Access Compliance Report Public Rights-of-Way (RR Crossings)

Intersection ID: 50271	Main Street: CLANTON_RD	Location: N/A
ADA ID: 6BDD4074BE7A	Overall Compliance: No	Severity Score: 0.0
Codes/Mitigation Info/Possible Solution		Field Measurements/Component Compliance

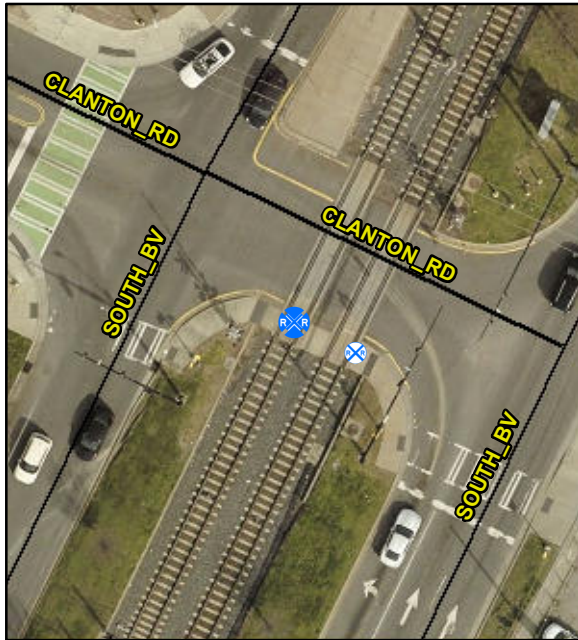
Compliance	Description	Data
Yes	DWS Provided?	Yes
Yes	DWS Contrast?	Yes
Yes	DWS Width (in)	Yes
Yes	DWS Length (in)	36.0
No	DWS Offset (in)	60.0
Yes	Pedestrian Gate?	Yes
N/A	DWS Outside Gate?	No
N/A	Rail Type?	LightRail
No	Flangeway Gap (in)	2.5
Yes	Sidewalk Width (in)	72.0

**Remove & Replace Detectable
Warning System. Remove & Replace
Walking Surface Adjacent to Rail.**
